## **Supplementary Information**

**Presentation from  
Paul Sedran, RESD Inc.**

Regulatory Oversight Report for  
Canadian Nuclear Power Generating  
Sites: 2022 and Mid-term update for  
Ontario Power Generation's Pickering  
Nuclear Generating Station

# Review of Submissions for the PNGS Midterm Review and the CNSC ROR for 2023

CT ID Profiles from the 2005 Inspection of Fuel Channel G-2 H14 with No Gap Calibration

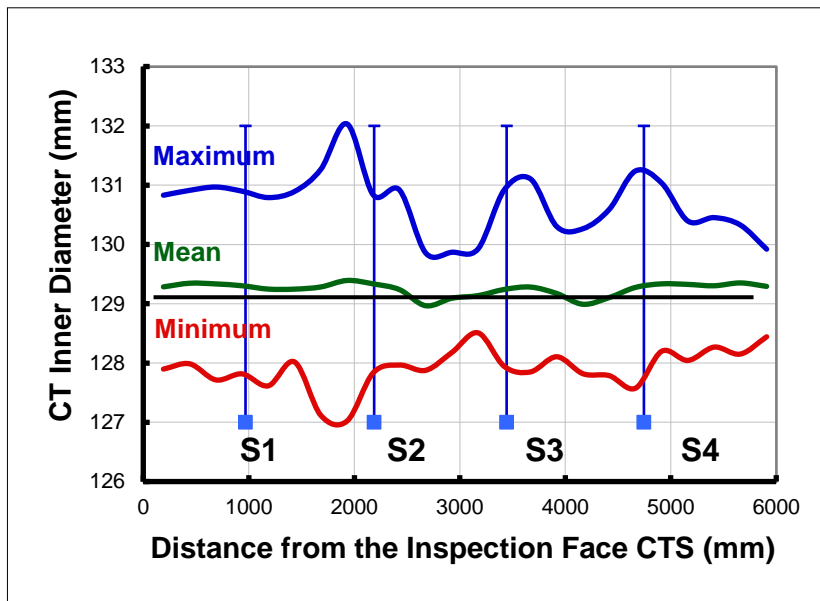
## 2.2 Validity of Gap Calibration

CT ID Profiles from the Gauging Measurements of  
The CT Removed from Fuel Channel P4M11

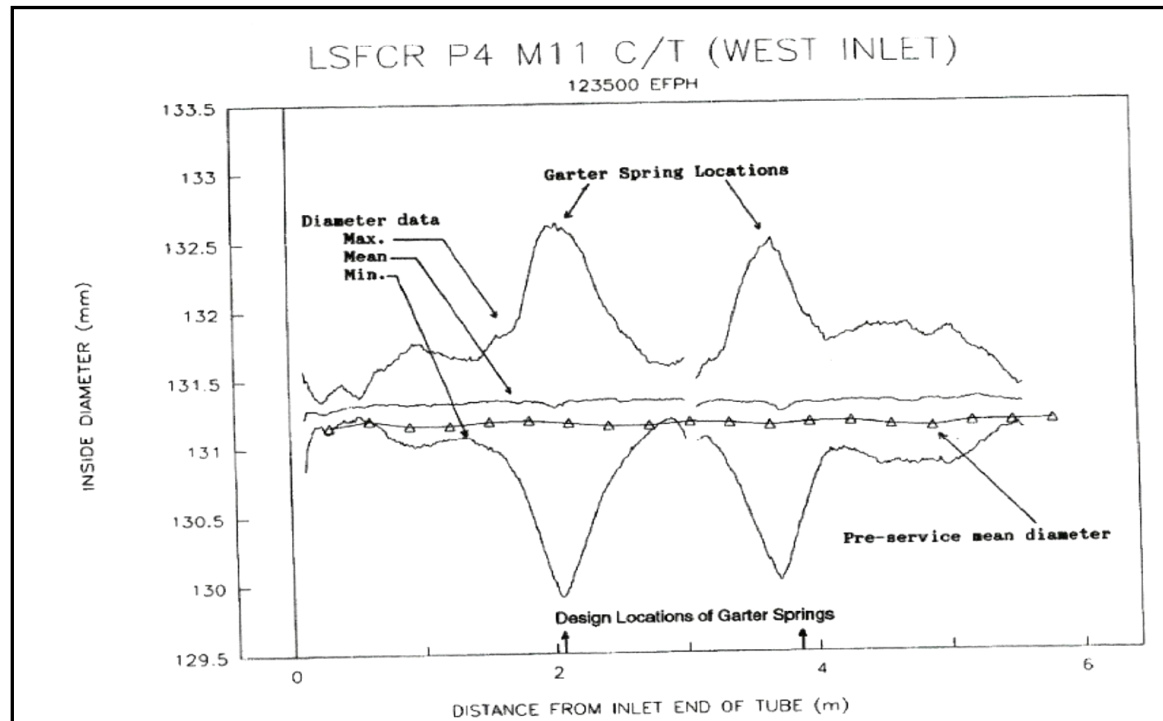
## 2.2 Validity of Gap Calibration Continued

As Measured and Calibrated Gaps for G2K07 versus Distance from the Inspection Face CTS

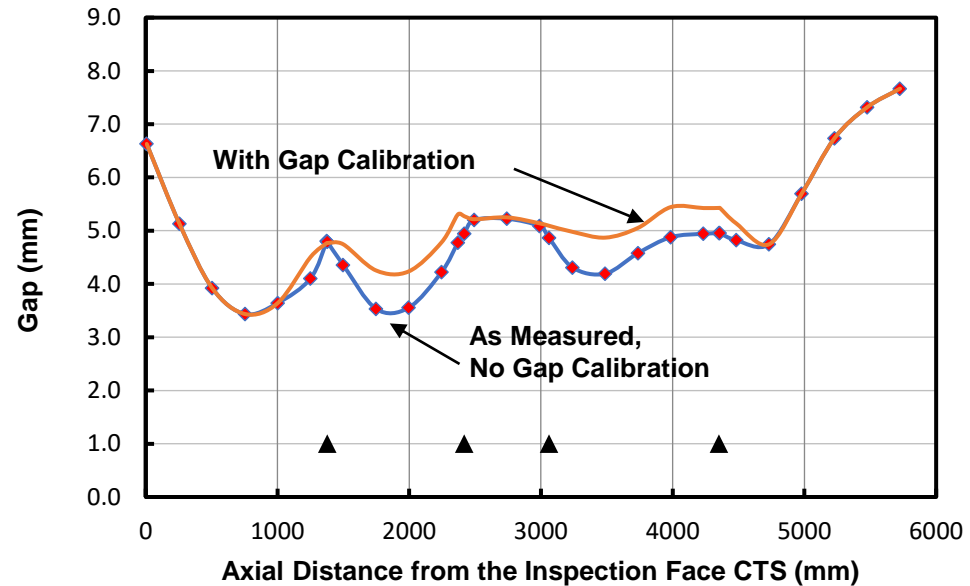
Calibration	x (mm)	EFPH (h)	Measured Gap (mm)	Fuelled Gap at x (mm)	Time-to- contact at x (EFPH)
None	1870.4	161000	3.430	3.427	417125
Calibrated	1897.9	161000	4.140	4.137	622061

1. In-service CTs are expected to have a nearly uniform mean CT ID profile over the length of the CT
2. With as-measured gap profiles, CT ID values conform to condition 1.
3. With gap calibration, CT ID values do not conform to condition 1.
4. The above indicate that gap calibration may be technically incorrect and further investigation will be required to make the finding conclusive.
5. With gap calibration, time-to-contact predictions may be anti-conservative.
